Transmission 722.6/9
Torque converter removed

Modification notes

P27.57-2004-06

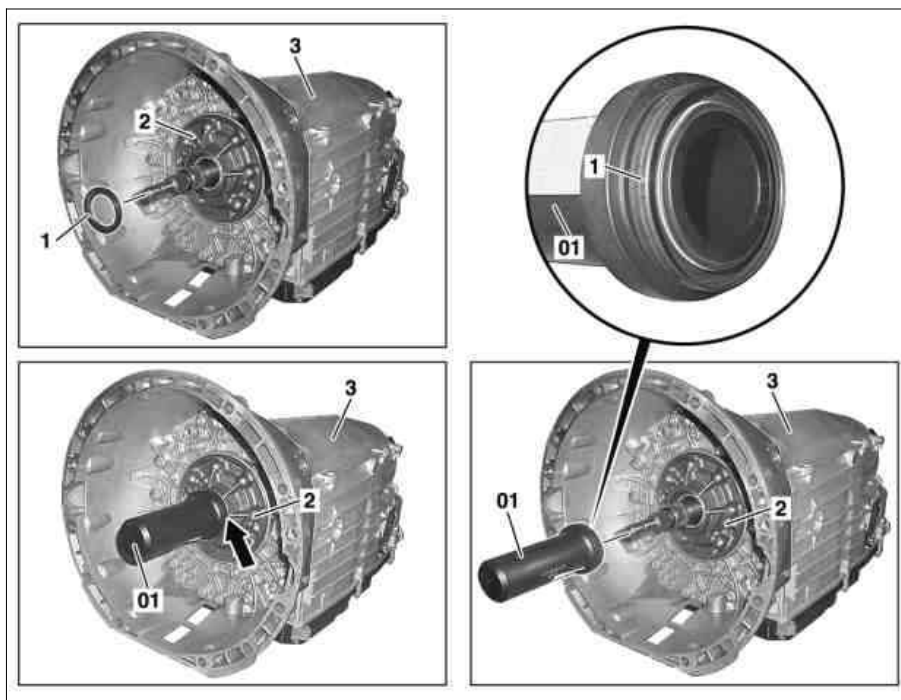
| 12.06.2013 | Drift 722 589 00 15 00 special tool replaced by drift 722 589 16 15 00 | Operation step 2 | |

| 2 | Install radial shaft sealing ring (1) flush using drift (01) | <ul style="list-style-type: none"> i Replace radial shaft seal (1). i Coat radial shaft sealing ring (1) between lips with multipurpose paste. Multi-purpose paste ☑ Drift | <ul style="list-style-type: none"> *BR00.45-Z-1009-06A *722589161500 |
